Charles Street Square upgrade

In March 2020, the City of Parramatta publicly exhibited the draft mail concept design for a proposed upgrade to Charles Street Square, Parramatta. The objective of the community consultation was to seek feedback from key stakeholders and the community on the proposed changes to the square.

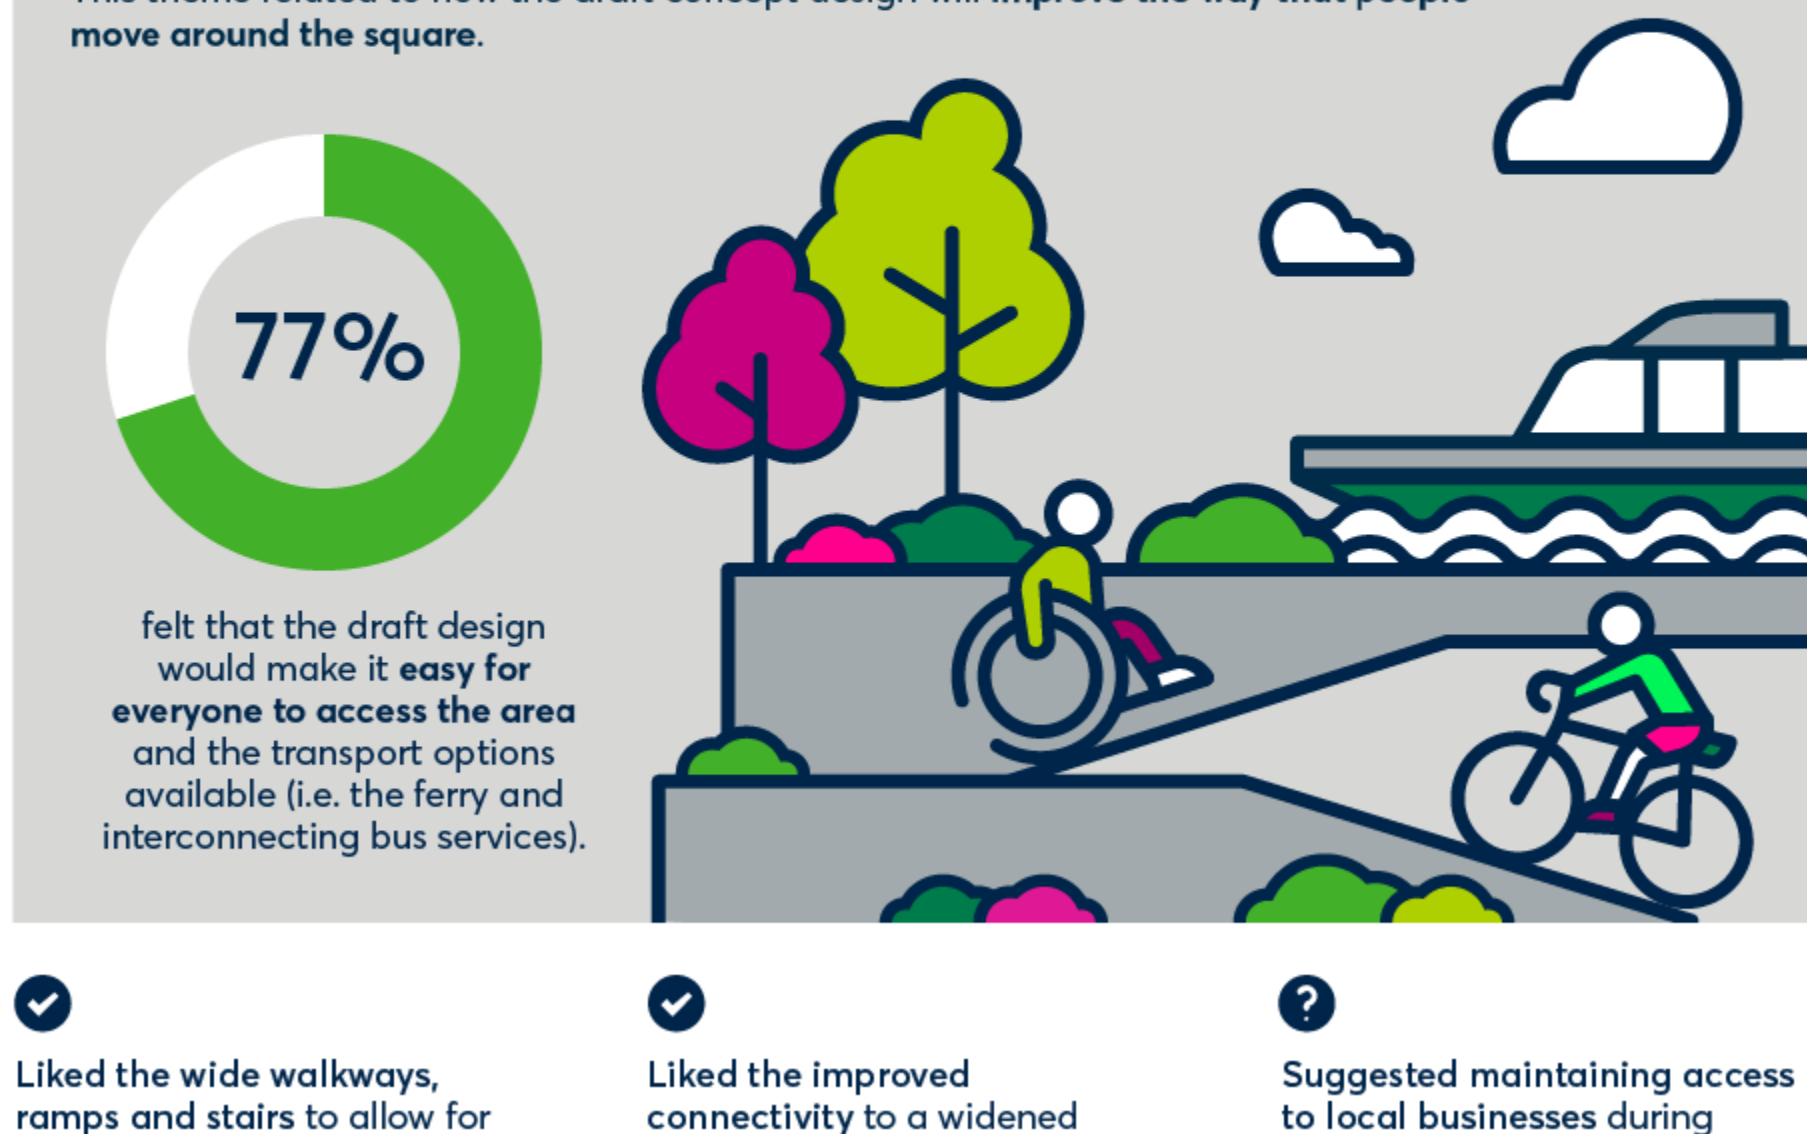
- ✓ Liked the **wide walkways, ramps and stairs** to allow for various modes of travel (i.e. walking, cycling, running), and that access for prams, wheelchairs and people with limited mobility has been improved.
- ✓ Liked the improved connectivity to a widened Parramatta River loop.
- ? Suggested maintaining access to local businesses during construction and operation was important.

- ✓ Liked the **variety and flexibility of seating and furniture** and that the provision of amenities like water bubblers, public toilets, bike parking, bike pump station, play equipment, and bins would improve the overall experience.
- ✓ Liked the **increased shade** and would like more of it.
- ? Suggested improved signage, for example to and from nearby entertainment venues or events, would improve their experience.

- ✓ Liked the opportunities for art installations and representations of Parramatta's identity.
- ✓ People also supported design elements which would see the space becoming a more welcoming place for families.
- ? Agreement on the need to increase safety, and for landscaping to include the use of native species. Also:
 - need for rubbish maintenance
 - prevent rubbish and graffiti
 - adjacent retail and commercial tenancies renovated/upgraded.

Enlarging the riverfront shelter to offer 43% more weatherproof area. This will be of benefit to visitors using the ferry service.
Four additional tall-trunked trees have been incorporated into the design to provide dappled shade while maintaining views to the Parramatta River. | More landscaping and green spaces
Together with the additional trees, more garden areas in the centre of the site (an extra 150m ²) and more planting on the Garden Terrace adds more green space to Charles Street Square.
The extent of hard surfaces, including concrete terracing, is reduced. The River Amphitheatre offers seating capacity for more than 400 people. |

The ferry office has been modified to incorporate a service window for customer interaction. Ferry staff are also provided with views of wharf operations.
The laser projectors essential to the public art project which features as part of Charles Street Square have been integrated into the roofline of the ferry office. | Access improvements
The amended design incorporates minor adjustments to ramps to improve clear width of the Riverfront Walk.
There is also a small reduction in the overall travel distance along the ramps between street level and the riverfront. Double handrails to all stairs better assist people travelling in either direction. |

The project now incorporates public space connecting the Garden Terrace to the existing arcade from Charles Street, the proposed colonnade of 180 George Street, and the rooftop terrace of 36 Charles Street. Raising this area improves public access. | Public spaces designed for easy maintenance
The amended design incorporates minor adjustments to ramp geometry to ensure maintenance equipment including street sweepers can be accommodated. Small retaining walls within the lower level garden beds will improve the flood resilience of our landscaping. |
